**MCPB**  
Item No. 4A  
Date: 6-24-21

## Burnt Mills Elementary School, Mandatory Referral, MR2021017

- Construction of a new school for a master planned capacity of 740 students; to include improvements to vehicular and bus access, parking, sidewalks, landscape, athletic fields, and stormwater management facilities;
- Location: 11211 Childs Street, Silver Spring MD;
- Property Size: 13.78 acres;
- Zone: R-90, 1997 *White Oak Master Plan*;
- Applicant: Montgomery County Public Schools.

Figure 6: MCPS Proposed Site Plan

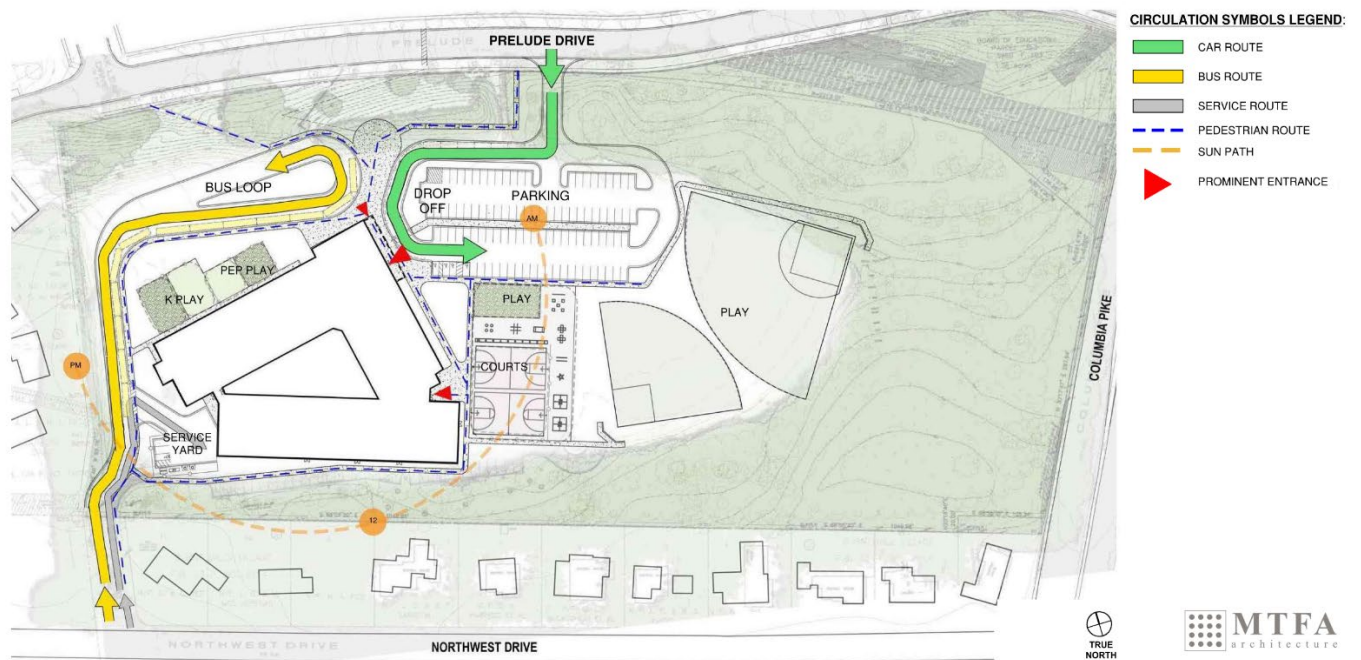
The proposal separates the pedestrian access, the car drop-off traffic and the bus loop traffic for safety. The main school entrance has been relocated to the north side, fronting on Prelude Drive, where a shared location is provided to connect all circulation types in front of the school's main entrance.

Buses will continue to enter the school via the existing entrance on Childs Street at the southwest corner of the site. The bus loop is located on the northwest side of the proposed building to provide queuing room for 13 buses. The student drop-off area with associated parking lot is accessed via a new driveway entrance on Prelude Drive, located on the north side of the site. The bus loop and student drop-off converge at the northernmost point of the building at a common entry plaza. A parking lot with 100 parking spaces is located east of the student drop-off and is accessed via the new driveway entrance on Prelude Drive. The loading area is located at the southwest corner of the building, near the bus entrance. Americans with Disabilities Act (ADA) compliant paths are provided from the new driveway entrance on Prelude Drive to the plaza in front of the main entrance and also at the Childs Street entrance.

The internal sidewalks proposed are a minimum of six feet wide, but ADA-compatible curb ramps should be provided adjacent to accessible parking spaces and at all marked crosswalks. At the new entrance to Prelude Drive, the sidewalks should be widened to six feet (within the Limits of Disturbance). Additionally, MCPS should evaluate the feasibility of raised pedestrian crosswalks or additional crosswalks between the surface parking lot and the recreation fields to maximize pedestrian safety and access.

MANDATORY  
REFERRAL SITE  
PLAN

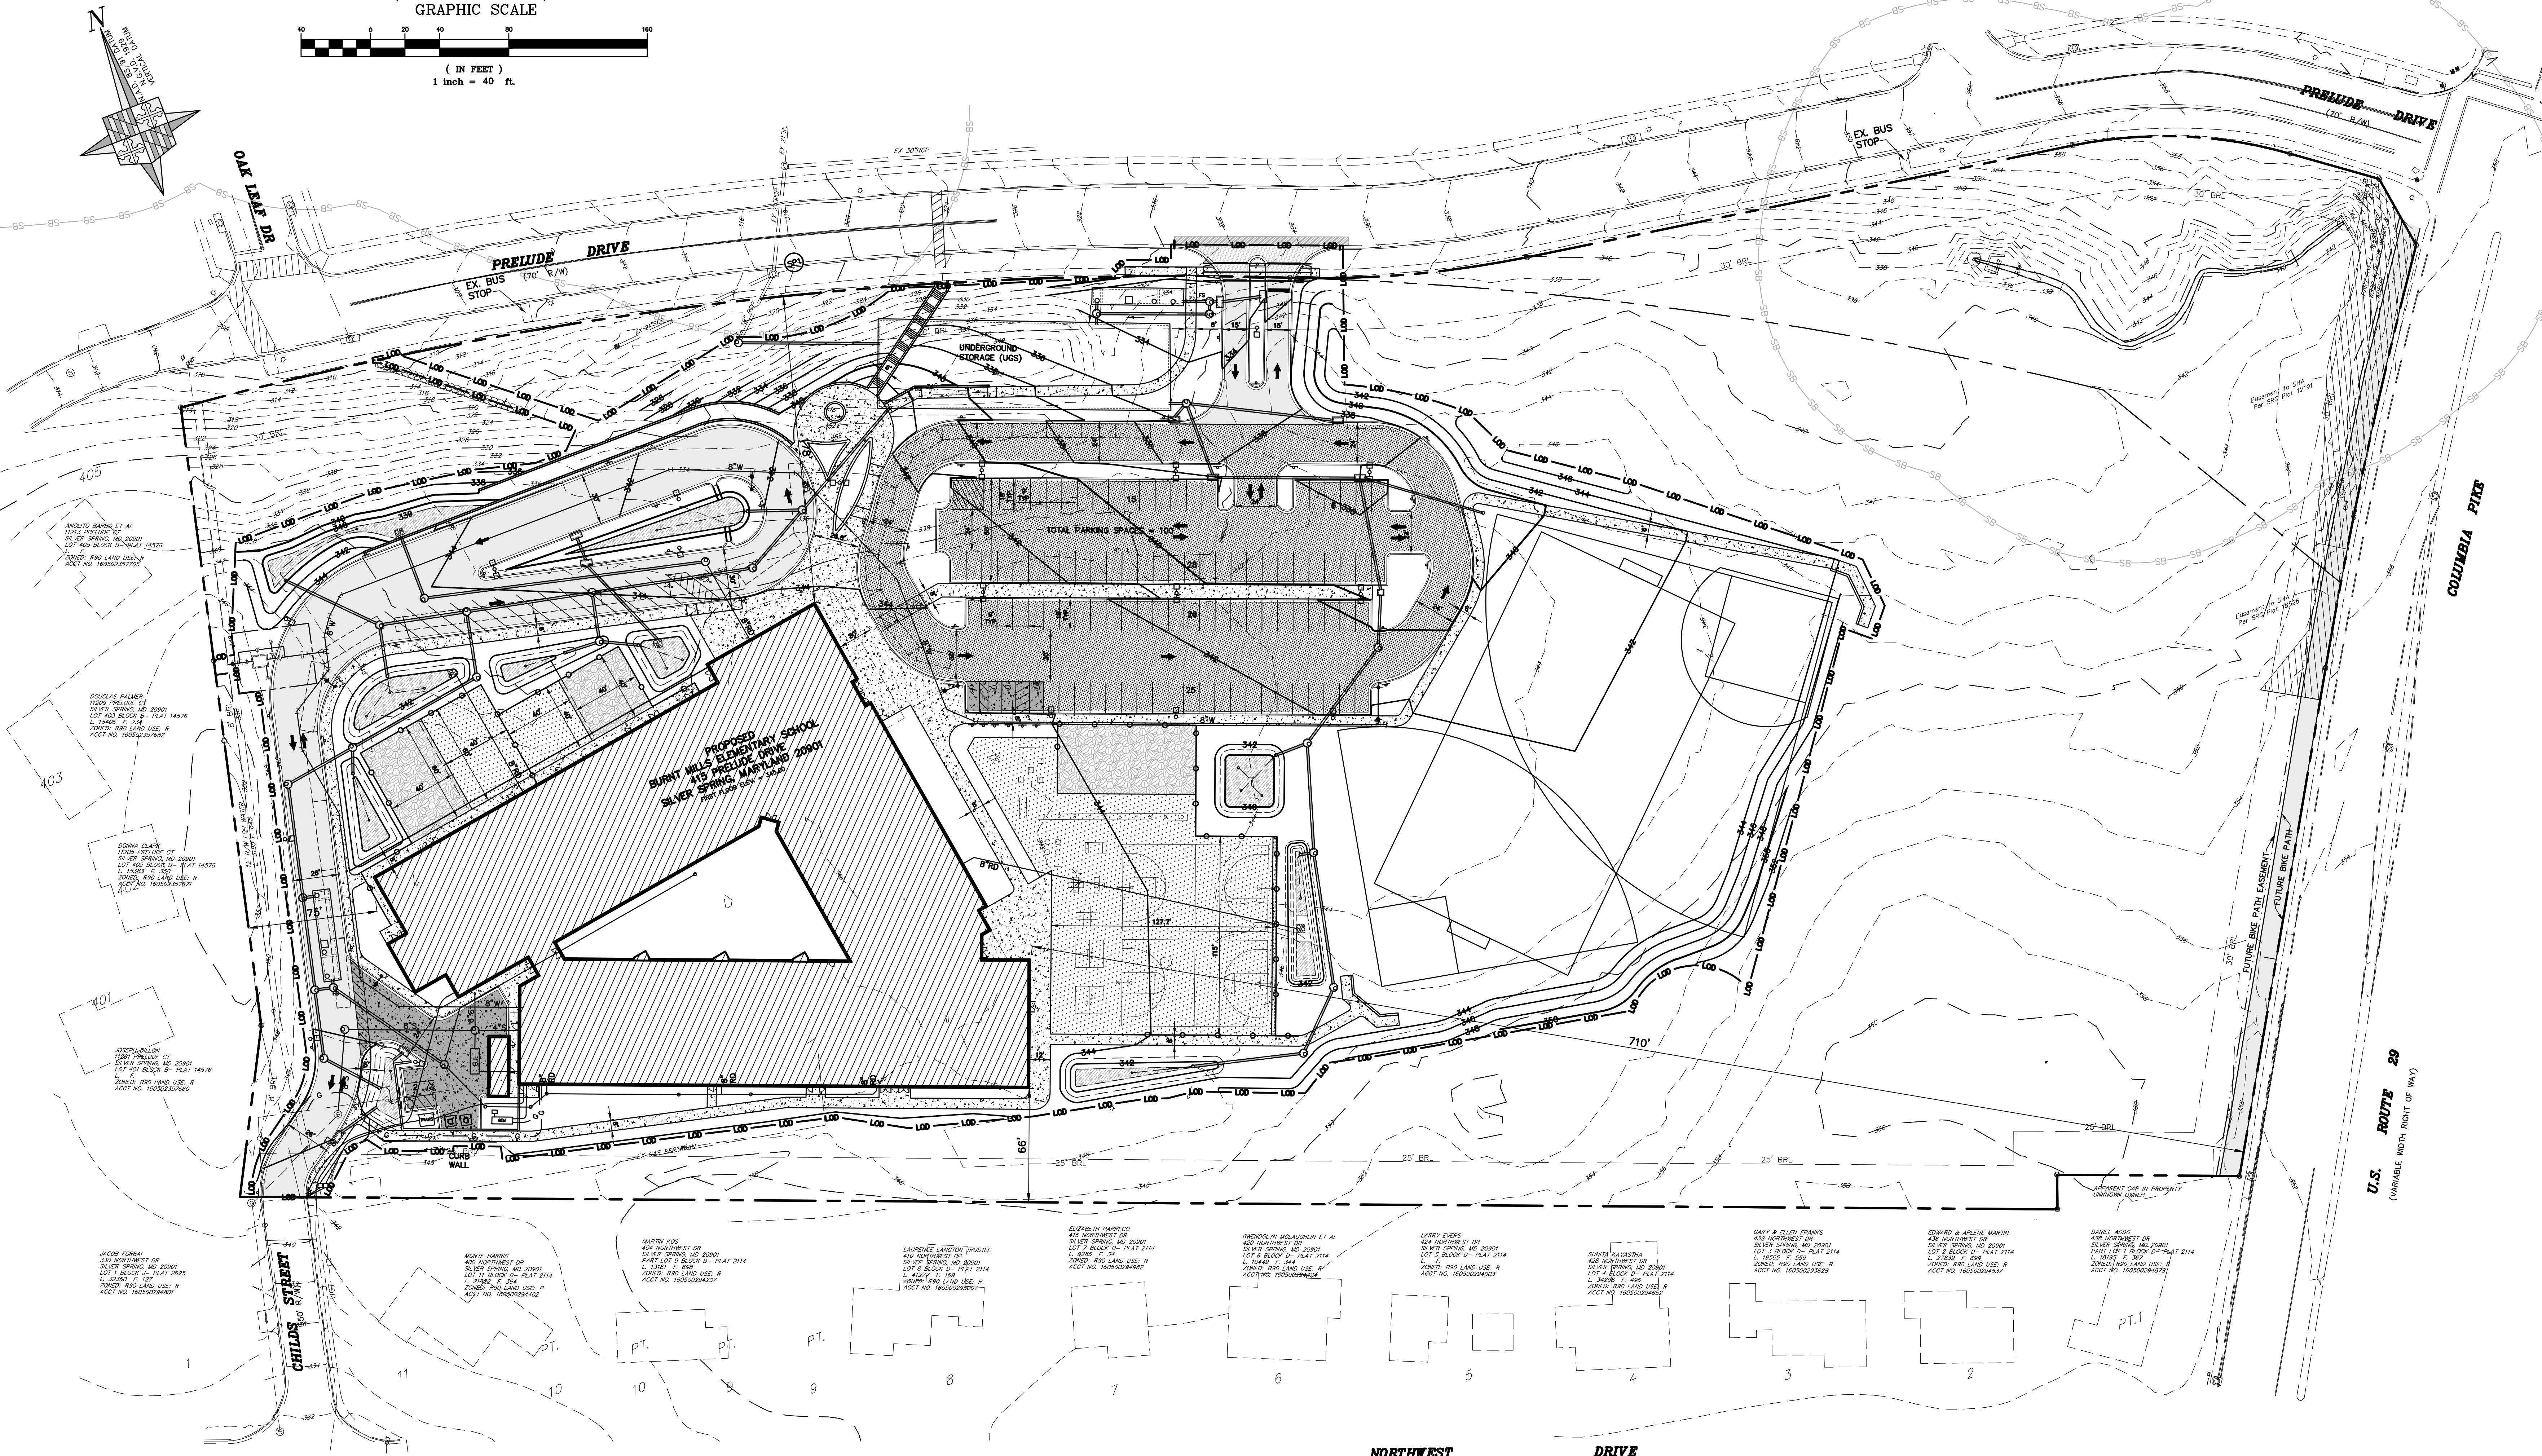
1. Comply with the approval conditions listed in the regulatory memorandum for the review of the related Final Forest Conservation Plan.
2. Create alternatives for the temporary use of the bus loop and parking lot area when not needed for vehicular use. Consider ways to provide areas for temporary athletic facilities, temporary passive recreation, or weekend neighborhood activities such as farmers markets or community festivals.

3. Submit a completed, executed Montgomery County Department of Transportation (MCDOT) Sight Distances Evaluation certification form for all existing and proposed site entrances onto county-maintained roads, for Montgomery County Department of Permitting Services (MCDPS) review and approval.

4. Explore opportunities to reduce the curb radii at the driveways of the pick-up and drop-off loop and surface parking lot to slow passenger car traffic moving in and out of the site;

5. Provide no less than 37 short-term bicycle parking spaces on site (U rack or equivalent).
6. Coordinate with MDOT SHA and MCDOT to construct a sidepath as recommended by the 2018 *Bicycle Master Plan* on the west side of US 29, along the school's eastern frontage. The sidepath should be a minimum of 11-feet wide, with an eight-foot wide landscape panel and two-foot wide maintenance strip between the travel lanes and the sidepath.
